York Street Interchange

Vector Re Routing
Proposal
Assessment

October 2015

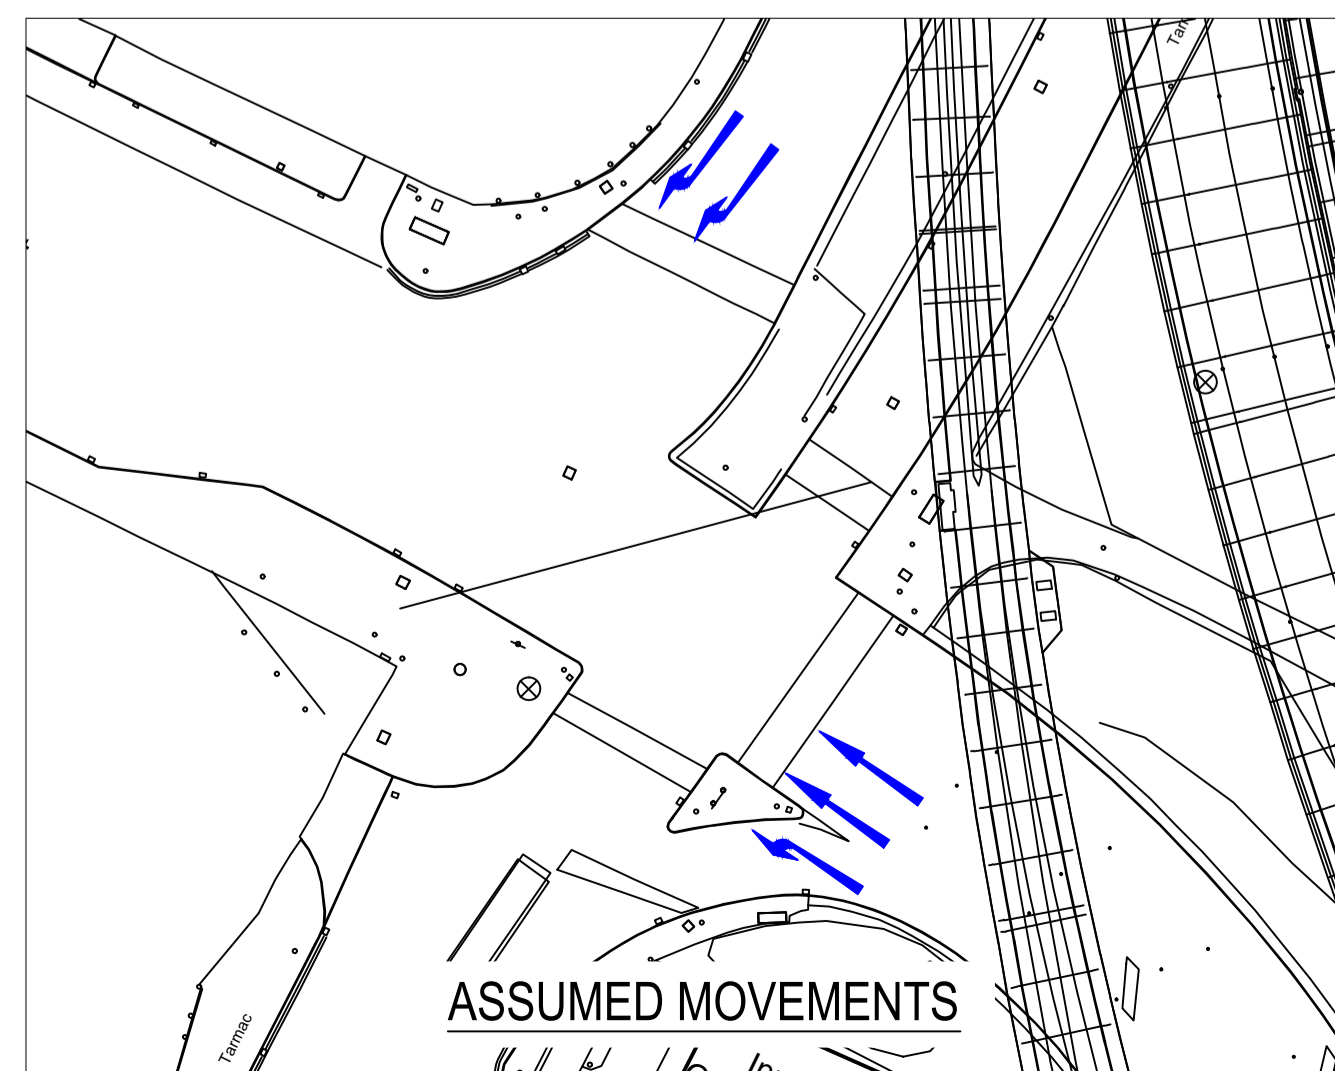
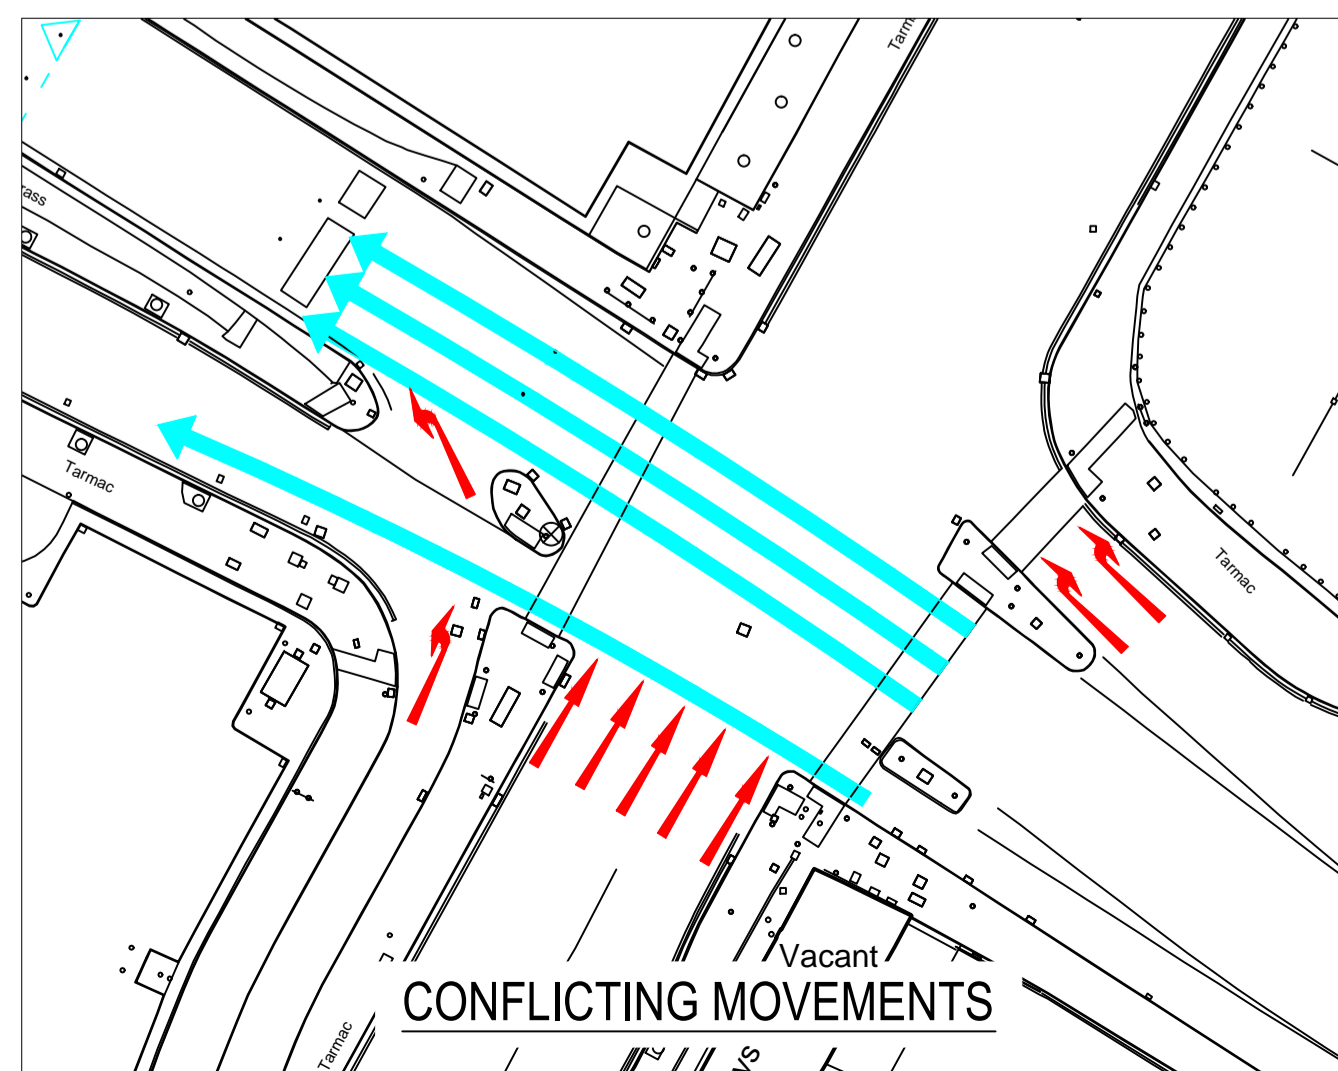
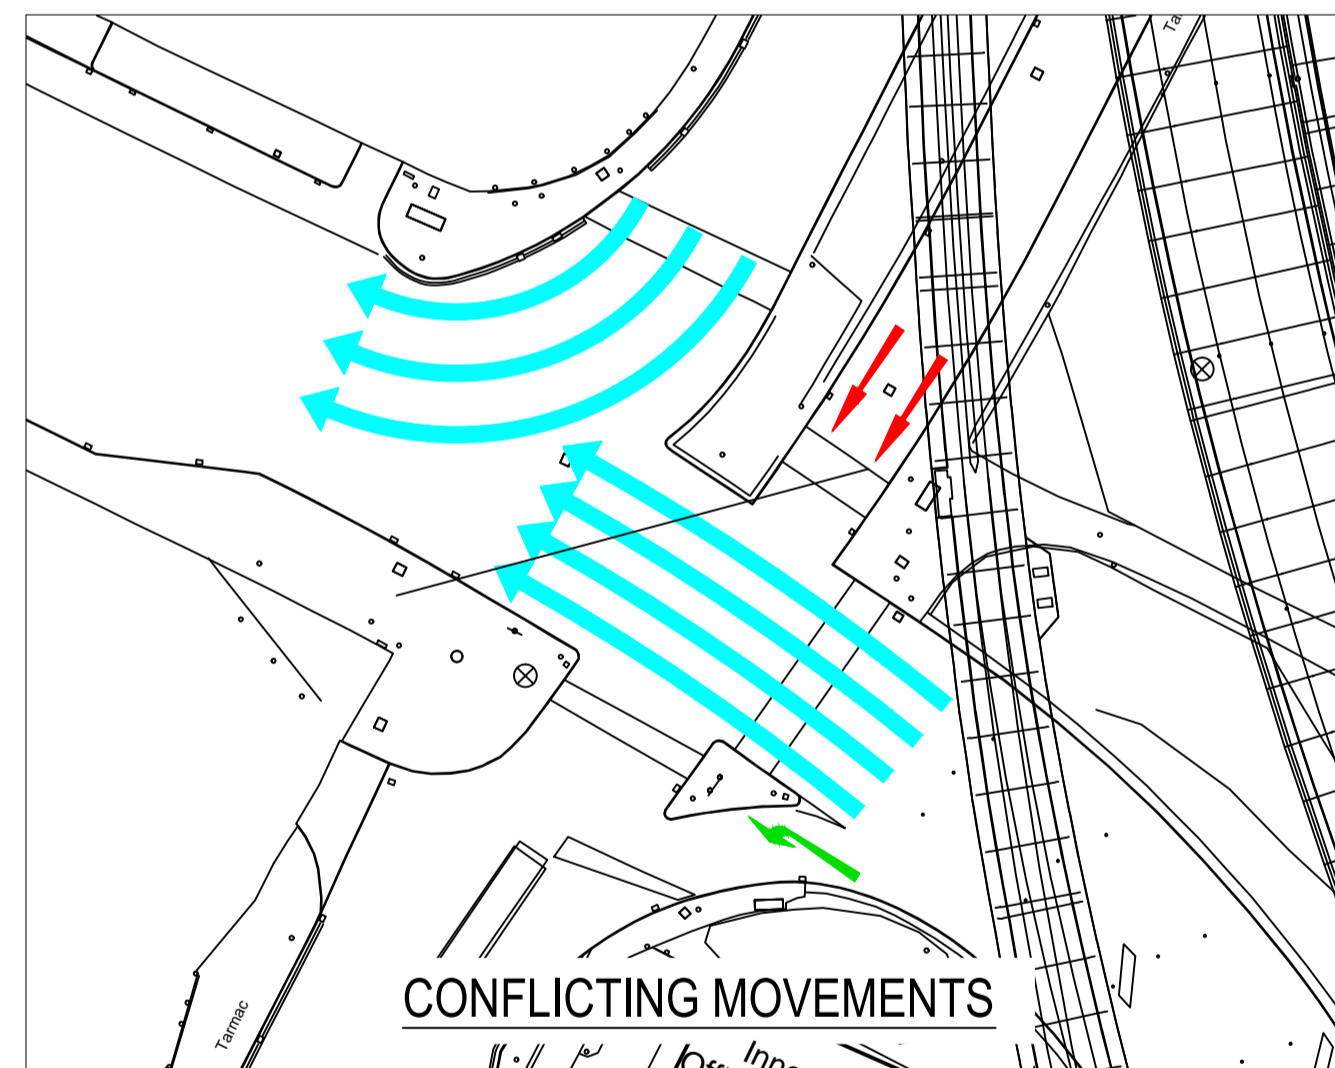
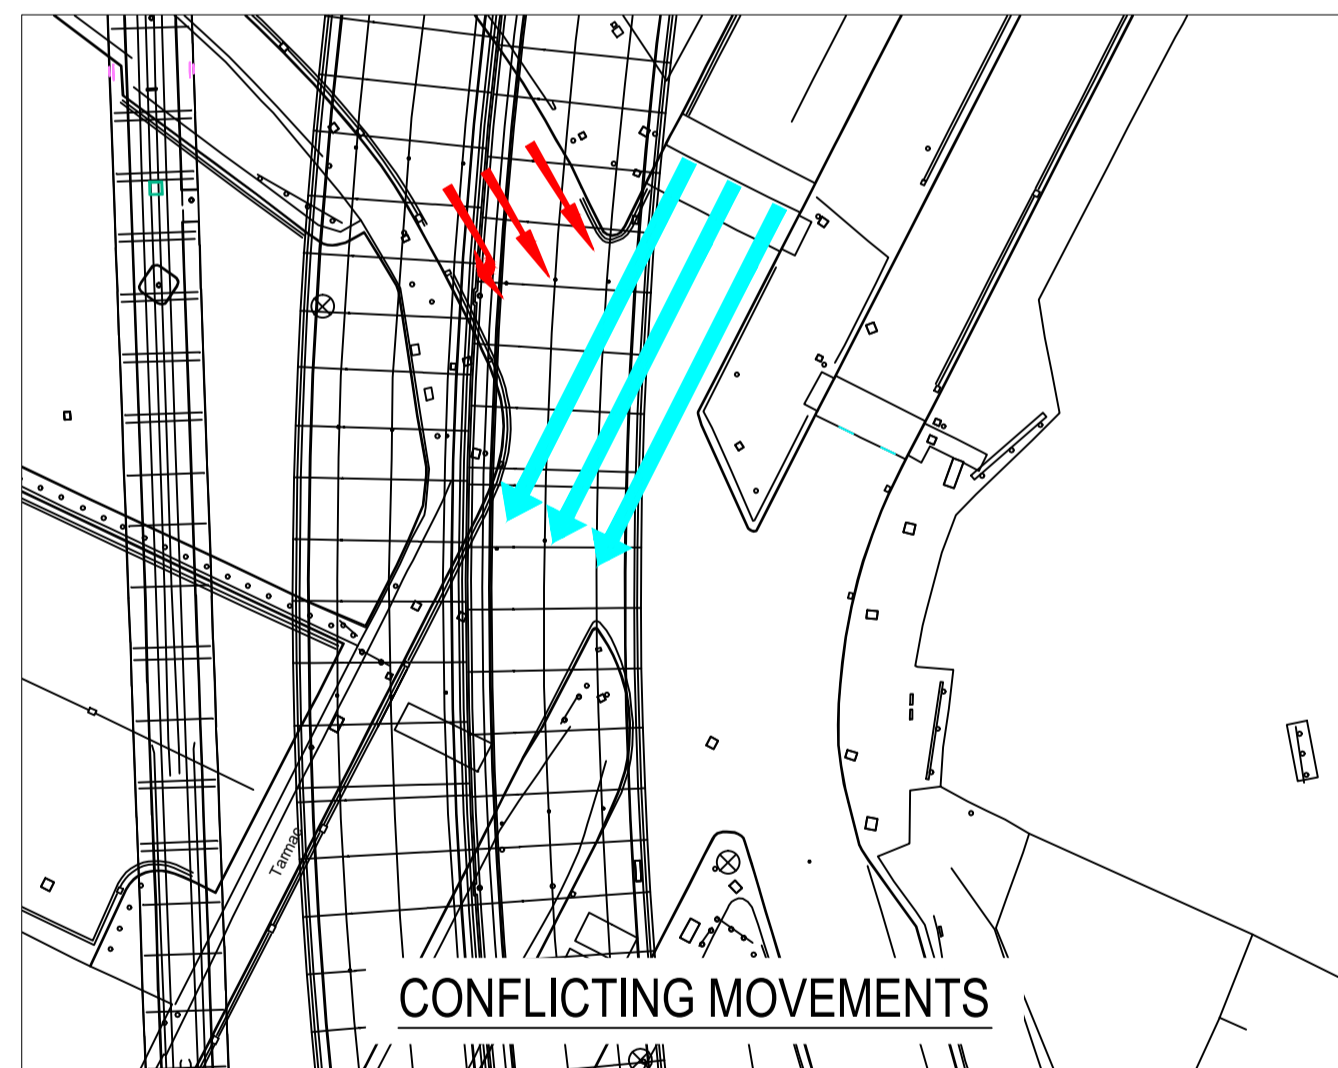
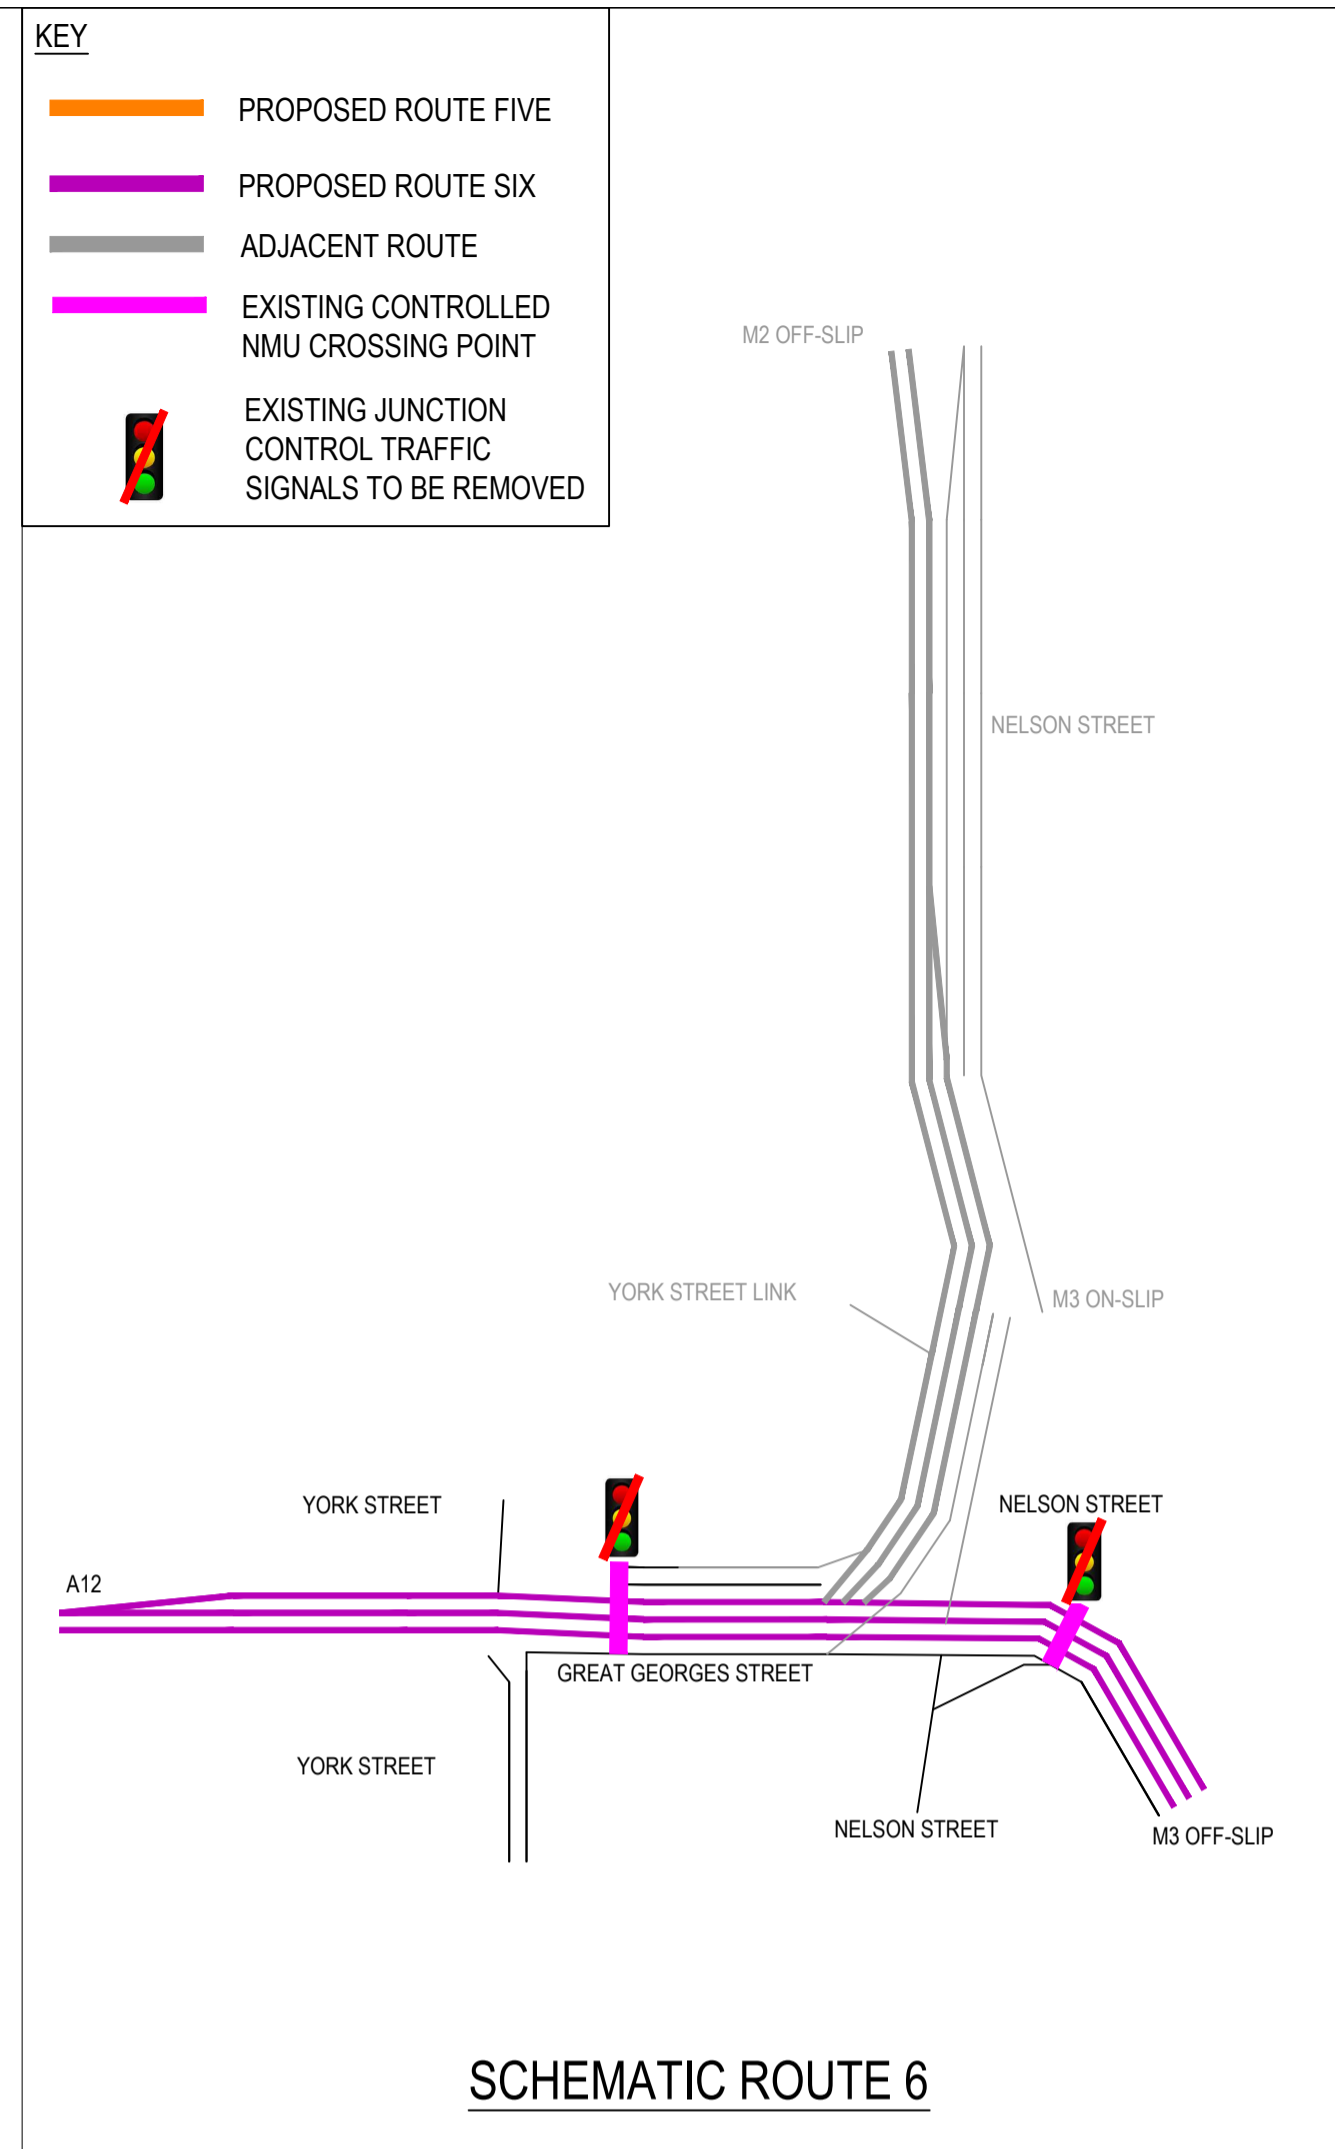
Drawing 6 in in Appendix A illustrates the Vector Proposal, along with a schematic diagram illustrating existing lane provision on the original and diversion routes.

The Vector Proposal does not provide sufficient details of lane configurations on Nelson Street and Great Georges Street. Based on the downstream capacity of the Westlink adjacent to York Street, only a maximum of three lanes can join the Westlink from Great Georges Street, reducing to two lanes at North Queen Street bridge. With the adjacent Route 6 providing a free-flow connection from the M3 to Westlink, it follows that only two lanes can be provided from Route 5, with lane two on the M2 to Westlink movement lost on approach to North Queen Street bridge. This lane reduction on the larger flows joining the Westlink from the M2 would likely create operational issues due to the effects of merging traffic.

In a similar manner to Route 5, the Vector Proposal does not provide sufficient details of lane configurations on the off-slip and Great Georges Street. This is particularly relevant given the downstream capacity of the Westlink away from York Street. With the adjacent Route 5 providing a free-flow connection from the M2 to the Westlink, with two lanes anticipated, it follows that only one lane can be provided from Route 6.

It would therefore follow that on the existing off-slip from the M3, the lane configuration would require alteration to reduce the number of lanes, similar to the Proposed Scheme. The Vector Proposal does not clarify the configuration but it could be reasonably assumed that the revised lane configuration on the off-slip would reflect that of the Proposed Scheme, with two lanes and a nearside auxiliary lane diverge. Of the two lanes, lane two would become the free-flow link to the Westlink and lane one would be designated for onward travel to Great Georges Street. The auxiliary lane diverge would be used to maintain the connection for City Centre via Nelson Street.
